ISOLATED ANALOG OUTPUT OPTION

New INF-B / DP41-B

Older-Style INF / DP41

Isolated Analog Output Option Card

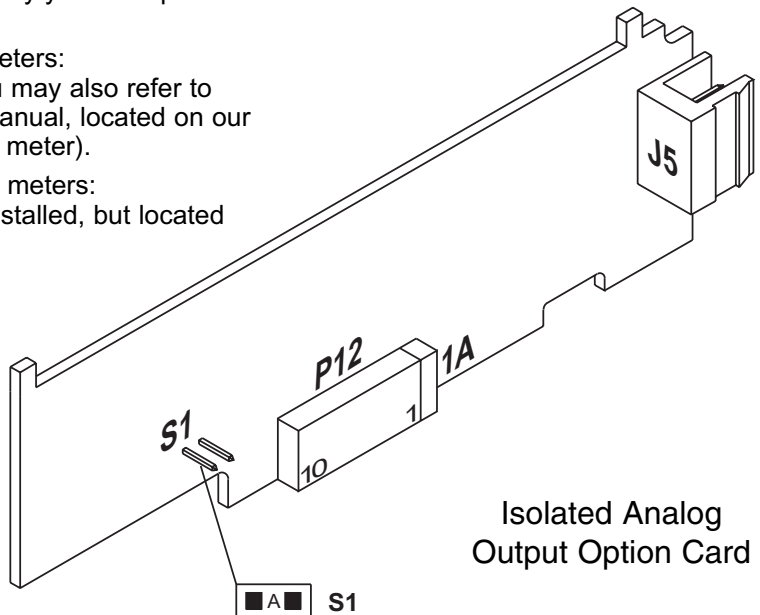
For this option card to work properly you must position the jumper **S1** as detailed below.

- For **New INF-B / DP41-B** meters: **S1-A** must be installed. You may also refer to the Analog Output Option Manual, located on our website (as listed on side of meter).
- For **Older-Style INF / DP41** meters: **S1-A** does not need to be installed, but located in a storage position.
